**OHIO TURNPIKE AND
INFRASTRUCTURE COMMISSION**

ADDENDUM NO. 1

SERVICE PLAZA RENOVATIONS

**CHANGES TO PLAN DRAWINGS
Sheet Number 6-A4.0, 6-A7.6, 6-8.1, 7-AS1.0 and 7-A8.1**

6-A7.6

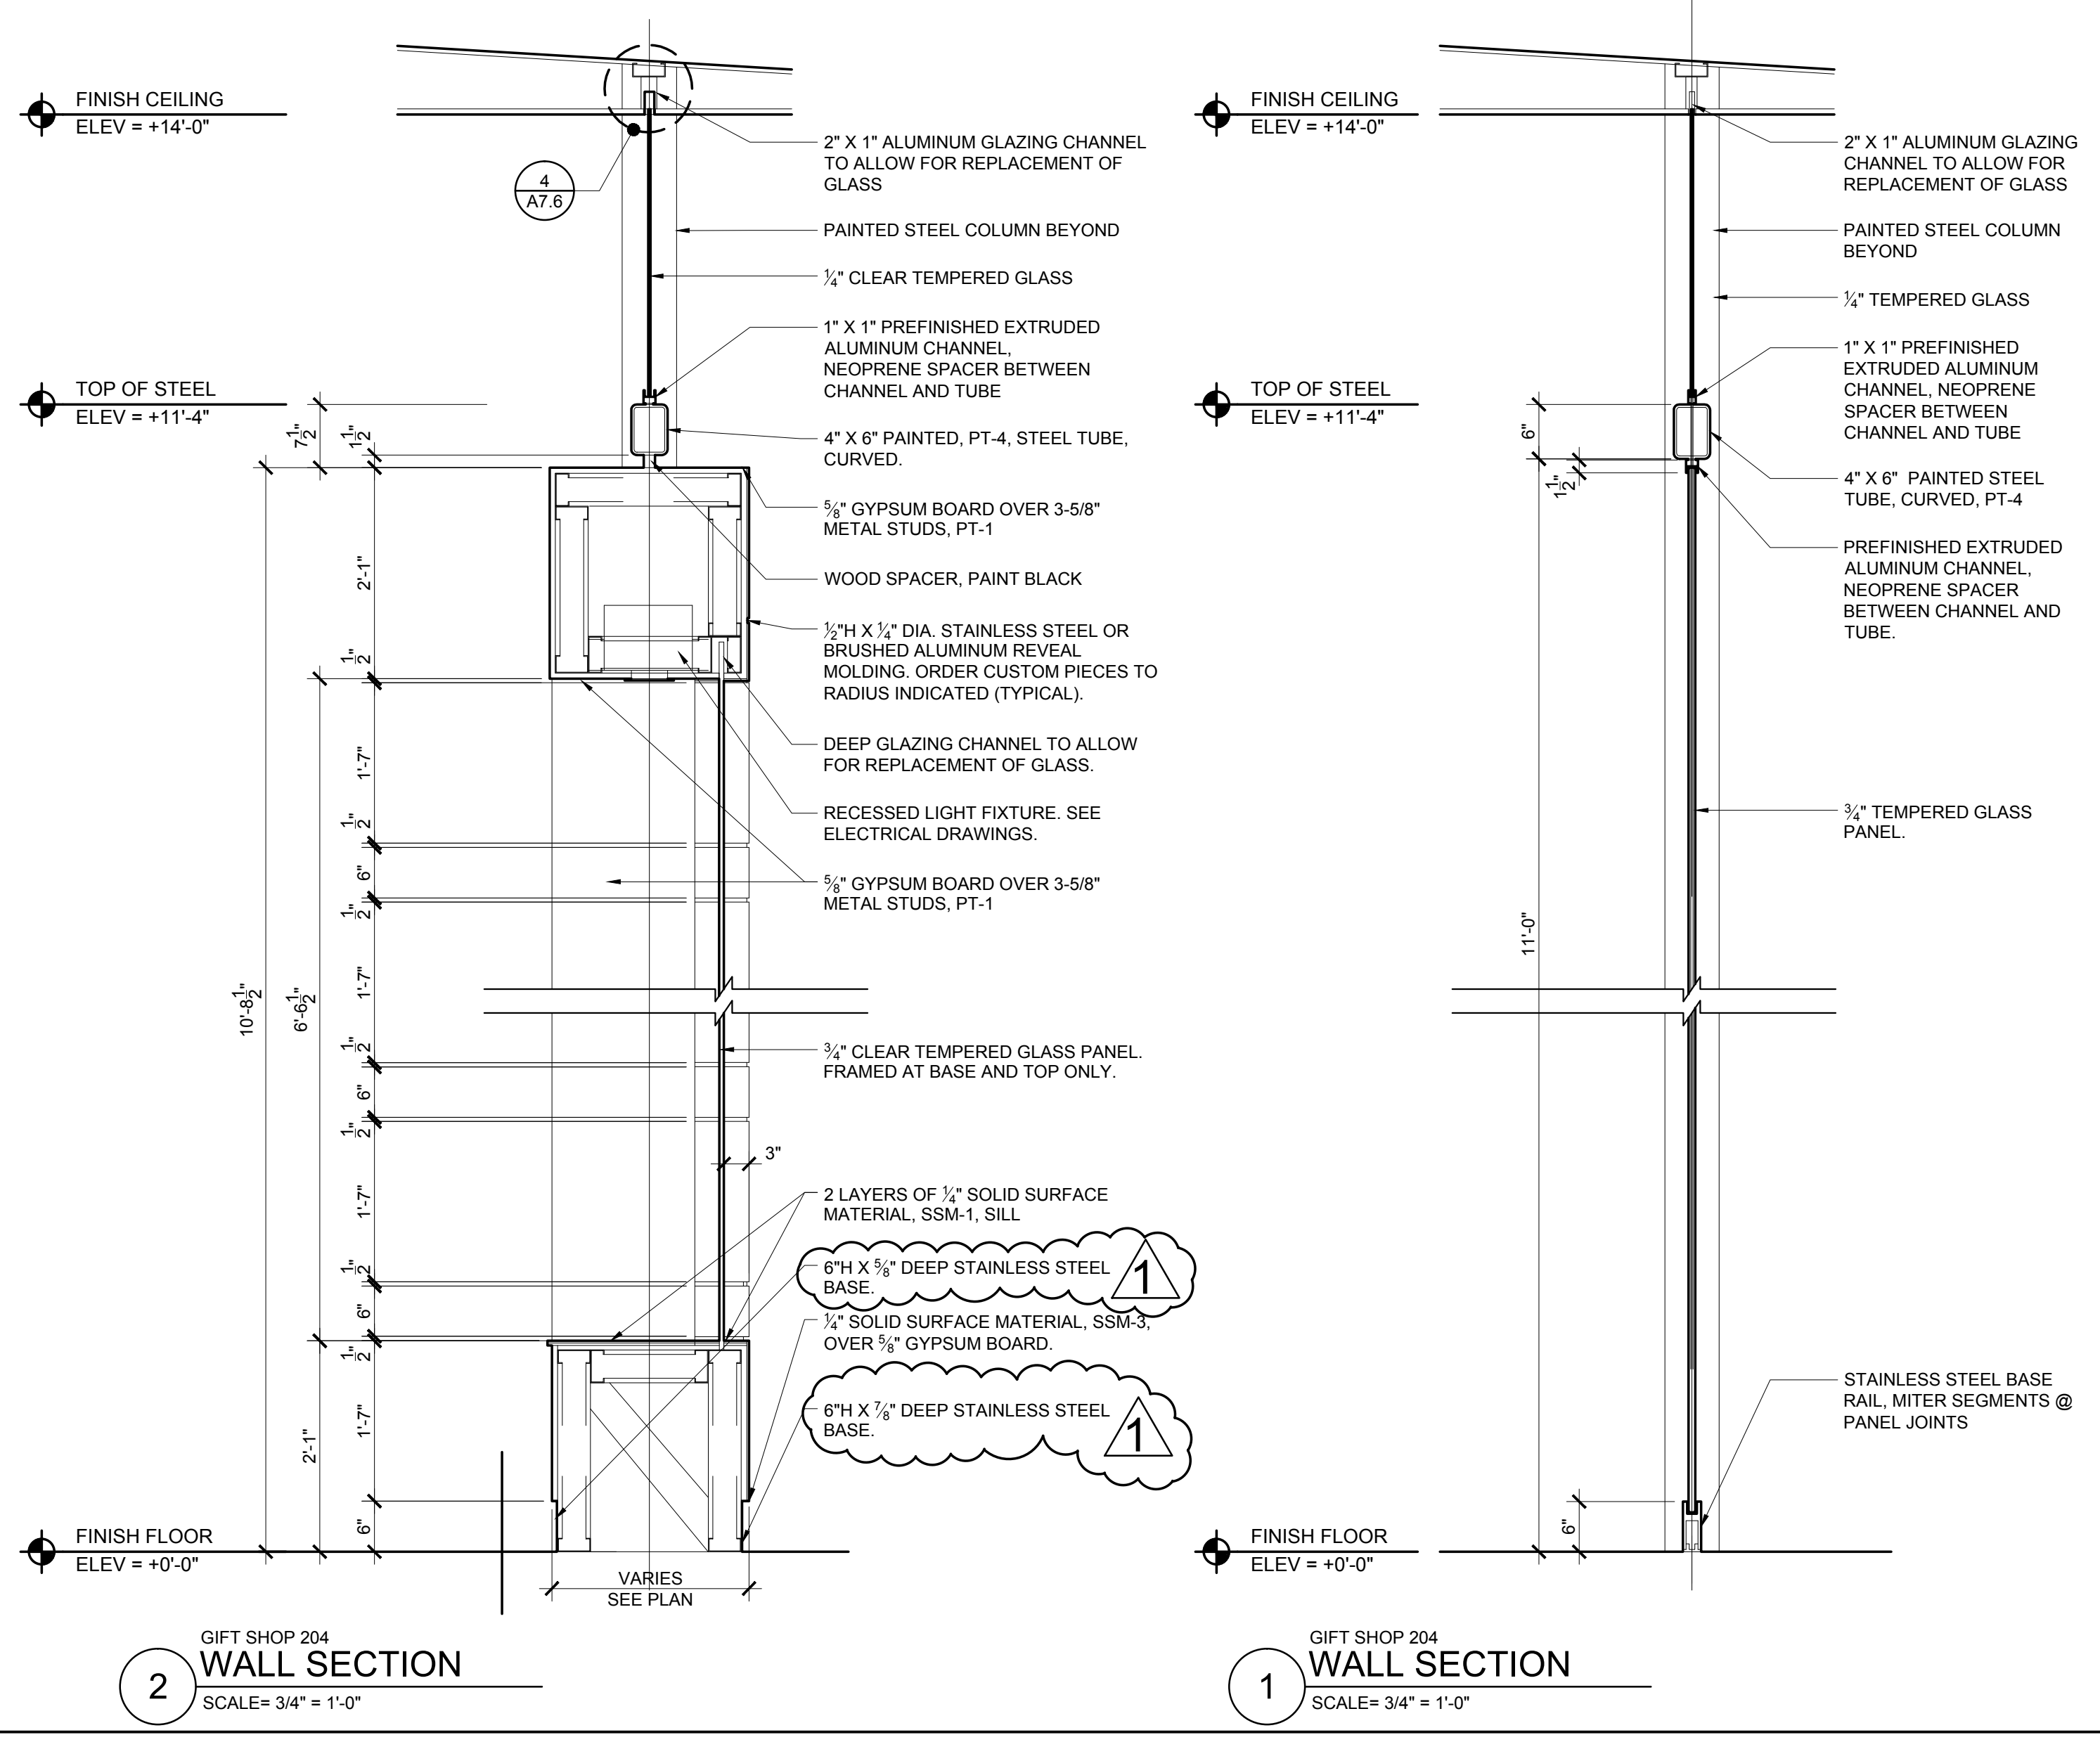
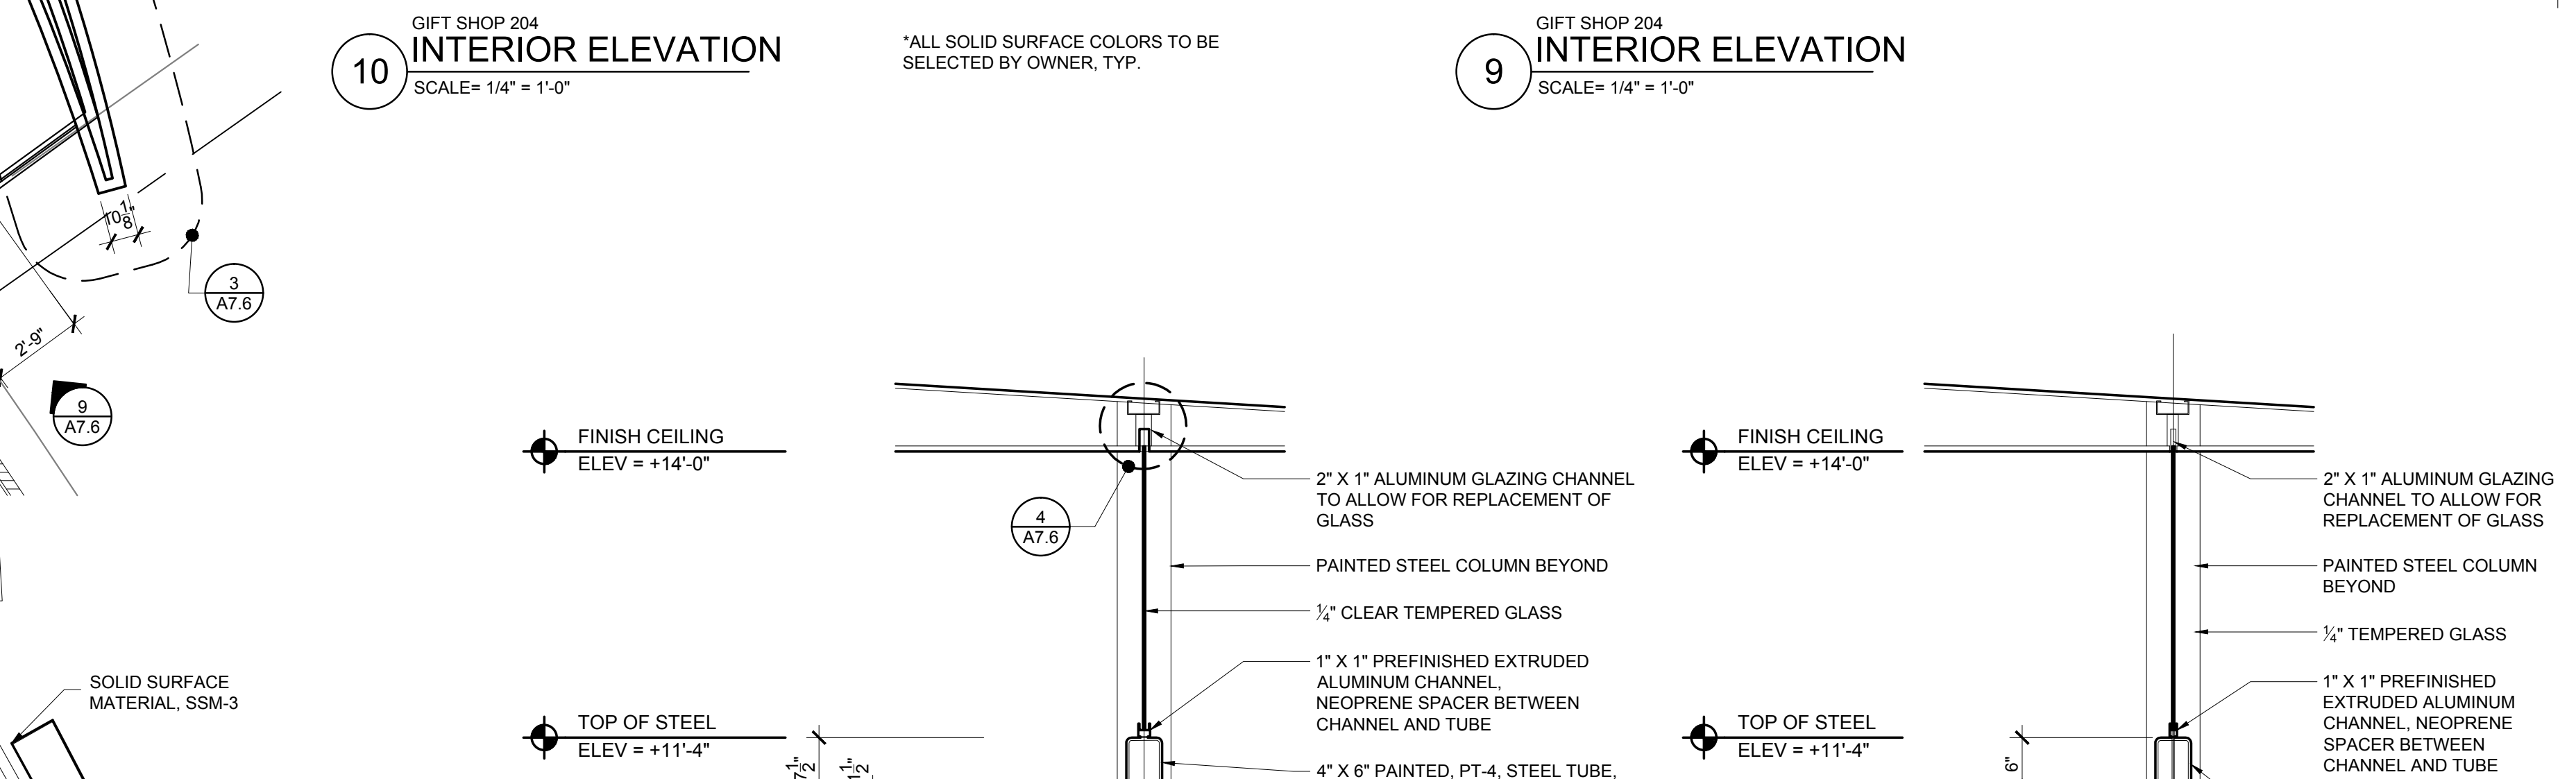
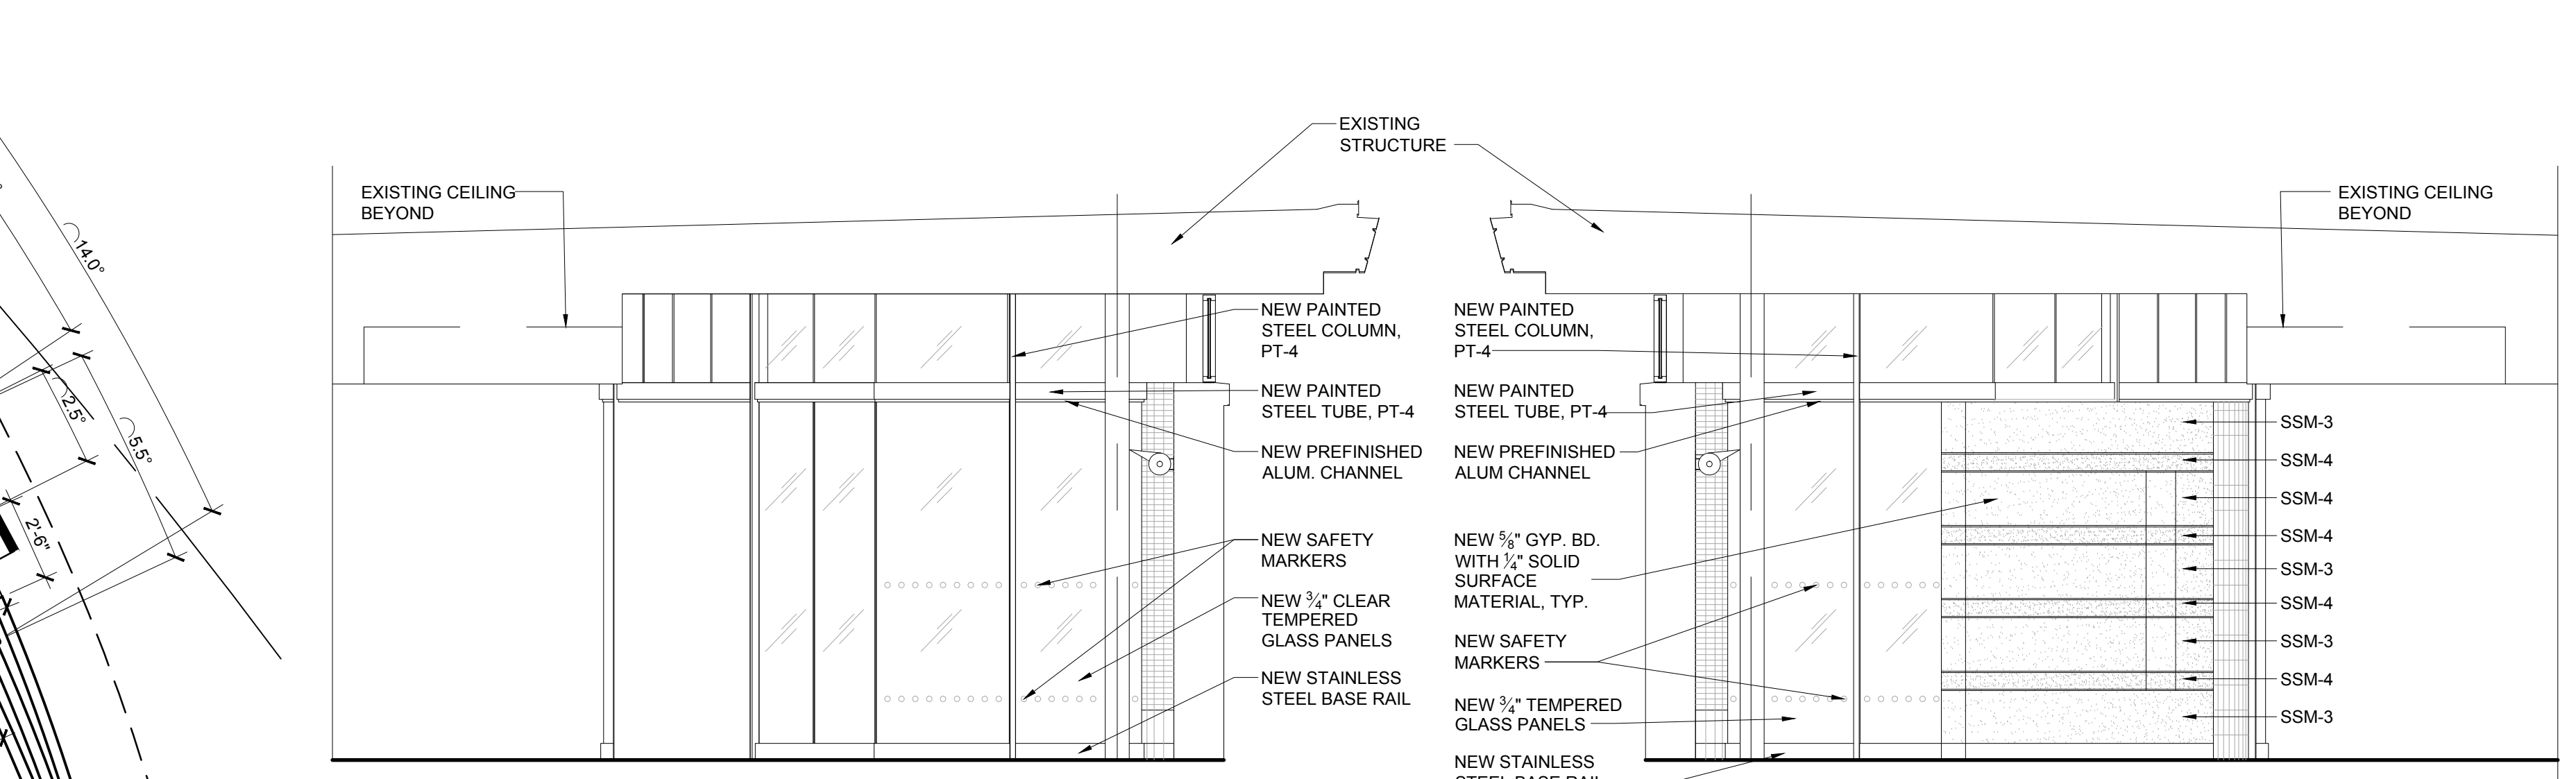
Q#11 Wall section 2 on 6-A7.6 shows a 6"H x 5/8" Dia. stainless steel base and 6"H x 7/8" Dia. stainless steel base. Please clarify what these items are.

A#11 The base dimensions should read 6"H x 5/8" Deep and 6"H x 7/8" Deep. This affects 6.A7.6 Plan Sheet.
